*Threats to possible orbital light-rail in outer London from the current **Brent Cross** planning application...*

# Brent Cross: transport

# Brent Cross: **now or never**

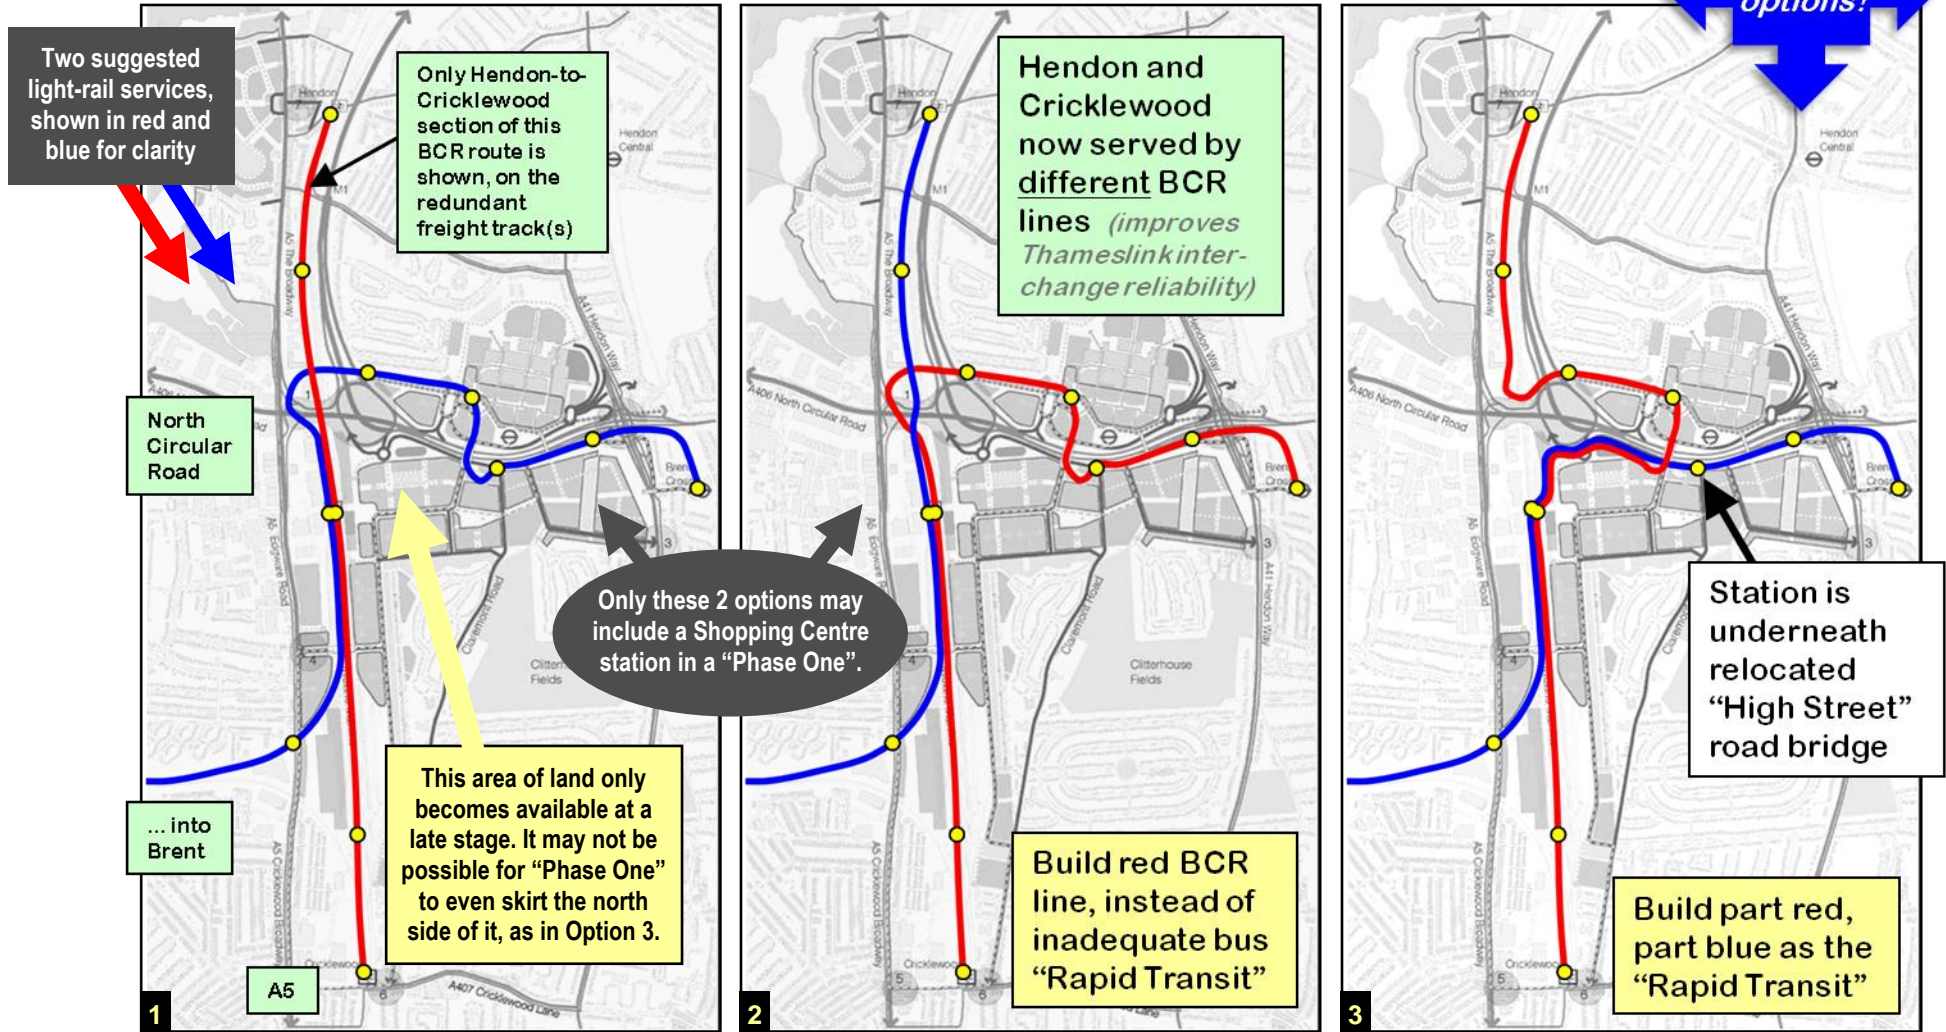
*Do we really want more of these brutalising and alienating pedestrian bridges? The plans for Brent Cross say that we do! They will have “step-free access”, as though that makes them acceptable in this new “town centre”. (Our web site has more detailed arguments .)*

**ROAD NEWS:** You will no longer be able to drive **south** on the A5 and turn **west** on the North Circular (except via new “spaghetti junction” roads at point “A”). **Why did the Highways Agency and TfL agree to this disbenefit?**

# Downtown “Brent Cross Town Centre”

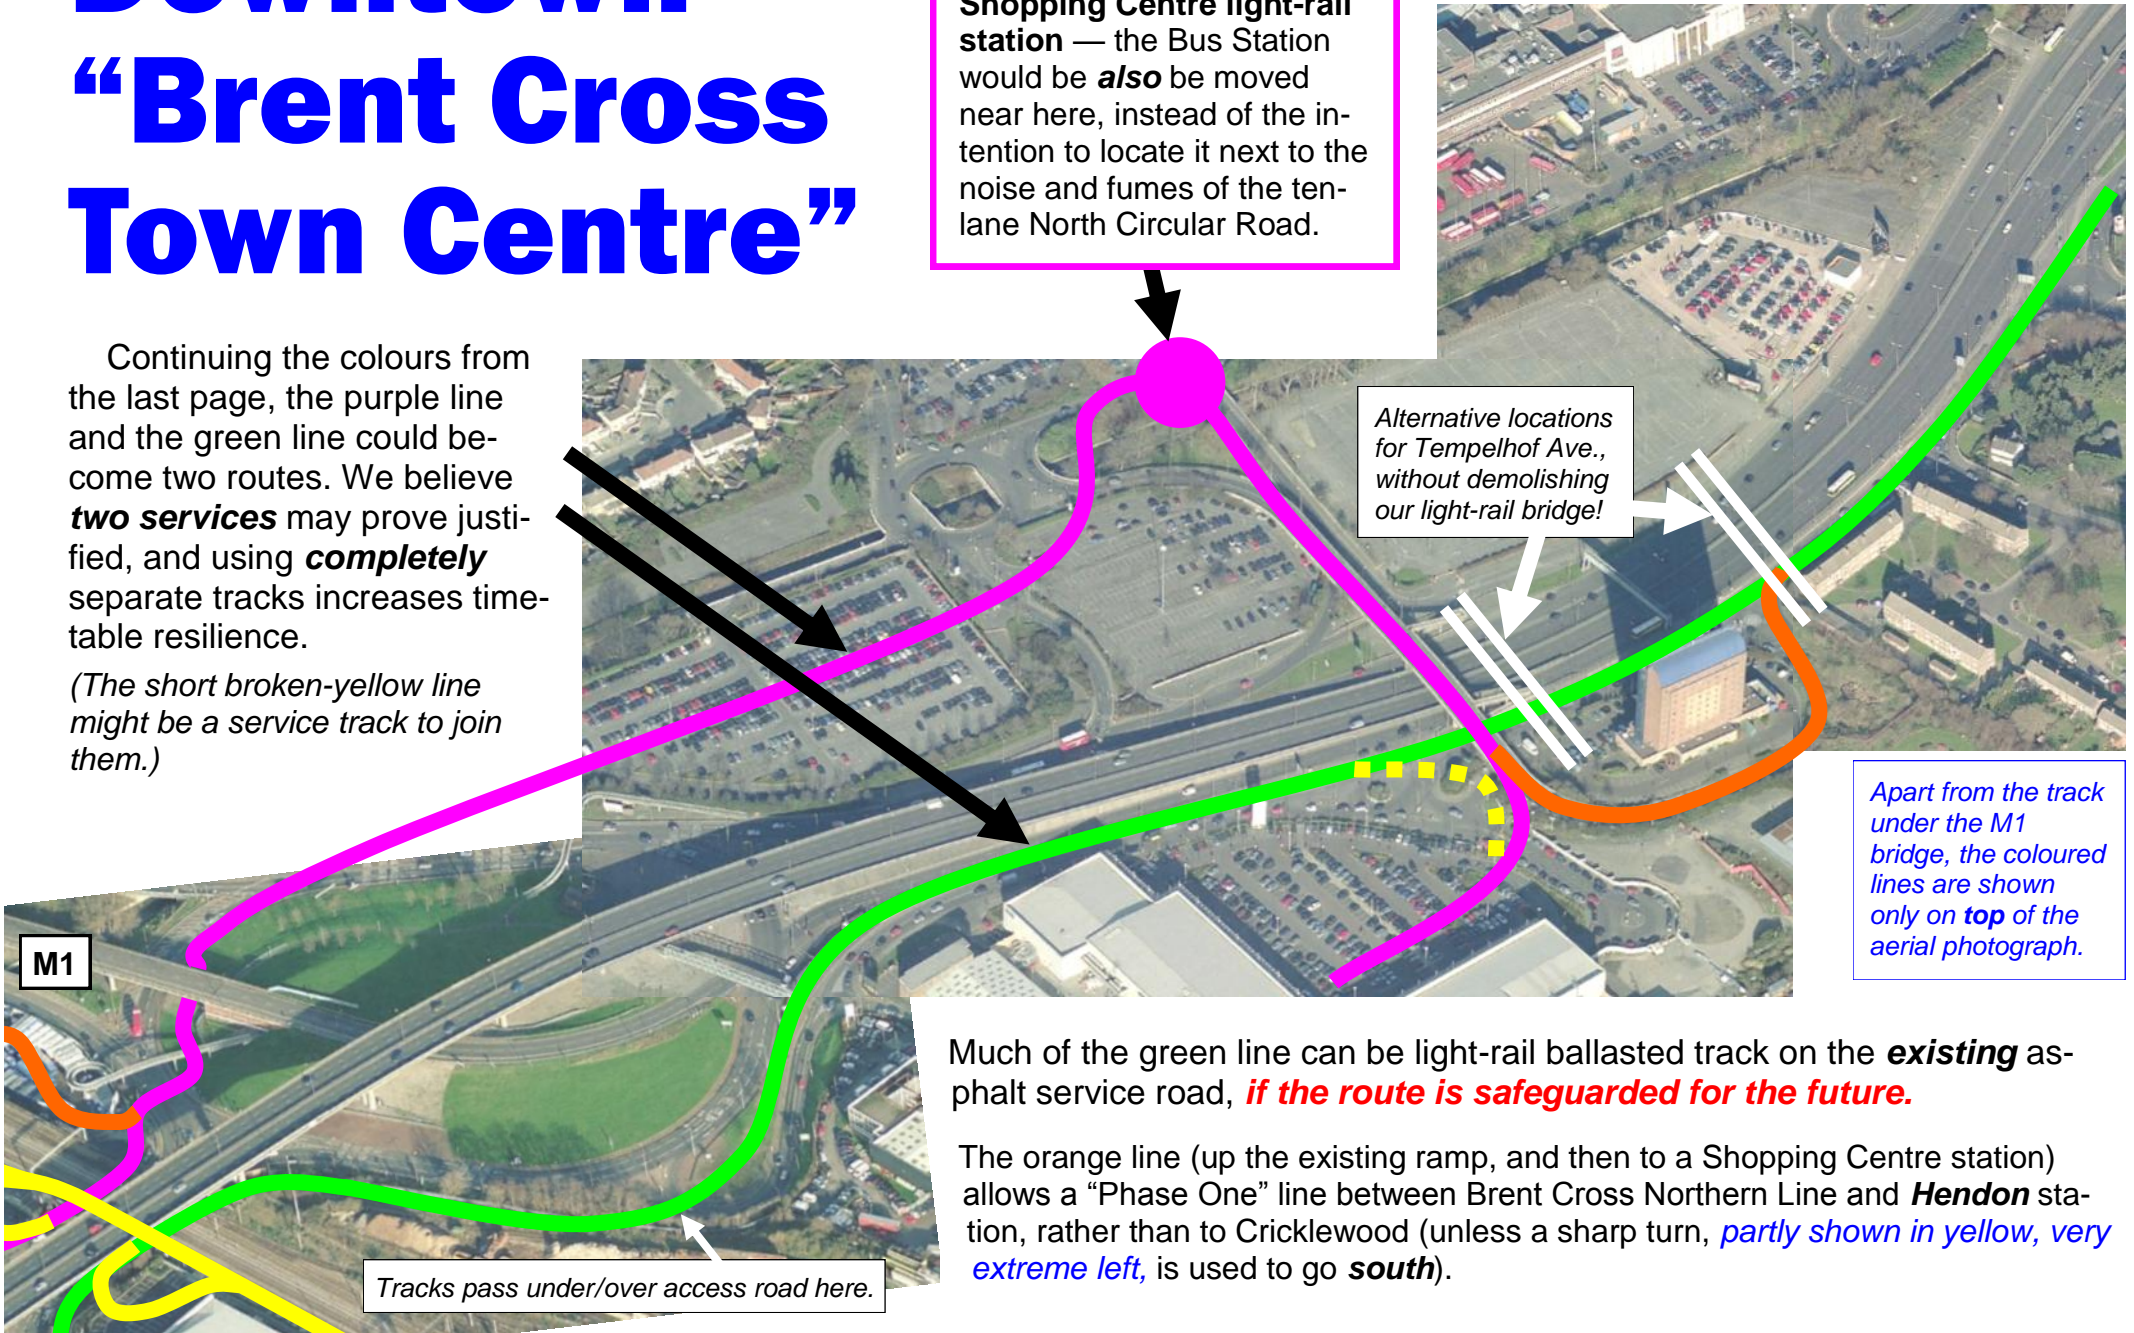
**Shopping Centre light-rail station** — the Bus Station would be **also** be moved near here, instead of the intention to locate it next to the noise and fumes of the ten-lane North Circular Road.

Alternative locations for Tempelhof Ave., without demolishing our light-rail bridge!

Much of the green line can be light-rail ballasted track on the **existing** asphalt service road, **if the route is safeguarded for the future.**

The orange line (up the existing ramp, and then to a Shopping Centre station) allows a “Phase One” line between Brent Cross Northern Line and **Hendon** station, rather than to Cricklewood (unless a sharp turn, **partly shown in yellow, very extreme left**, is used to go **south**).

# A41 roundabout changes

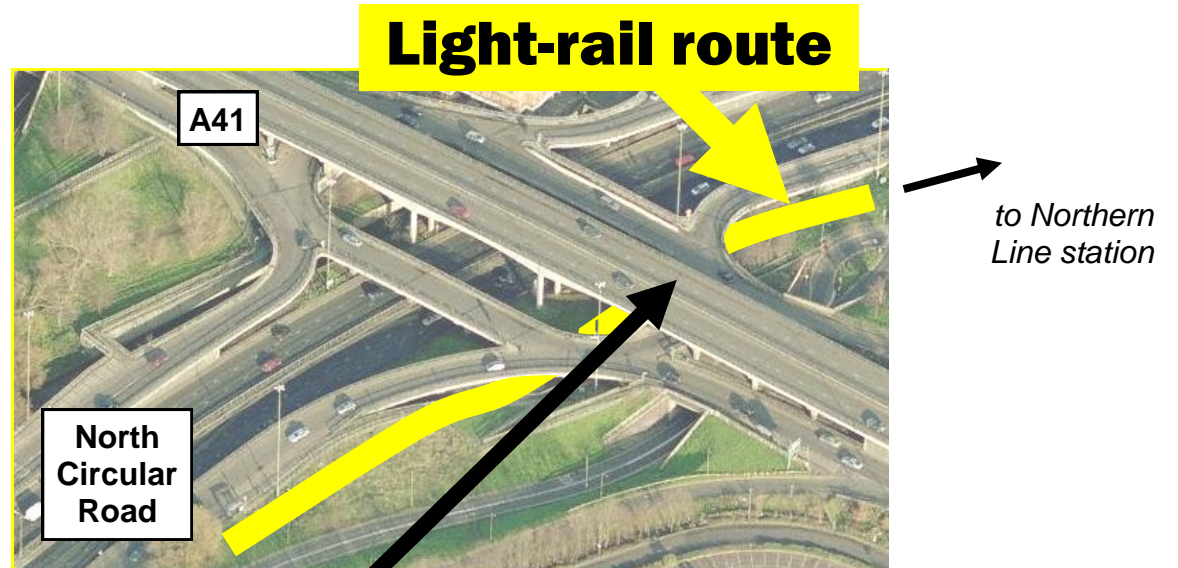
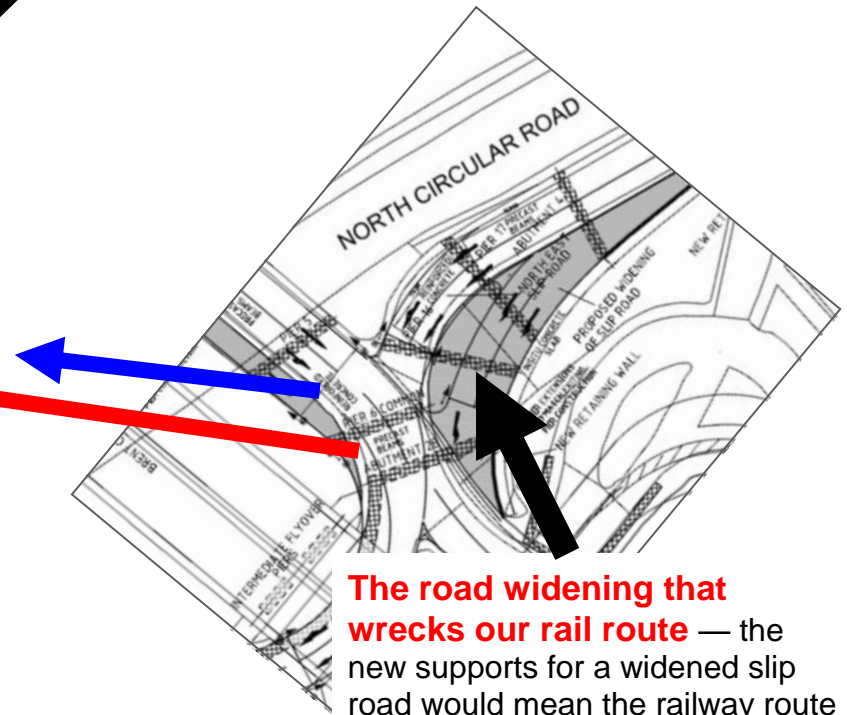
Either **this** span, or more likely, the **next** span to the left, could be used for light-rail.

**The road widening that wrecks our rail route** — the new supports for a widened slip road would mean the railway route would become impossible — and permanently so.

**New entrance to Shopping Centre** — we do not object to enlarging the A41 roundabout, since it means closing the short (and dangerous) slip road off the North Circular, just to the east, on the line of the light railway (at point \*).
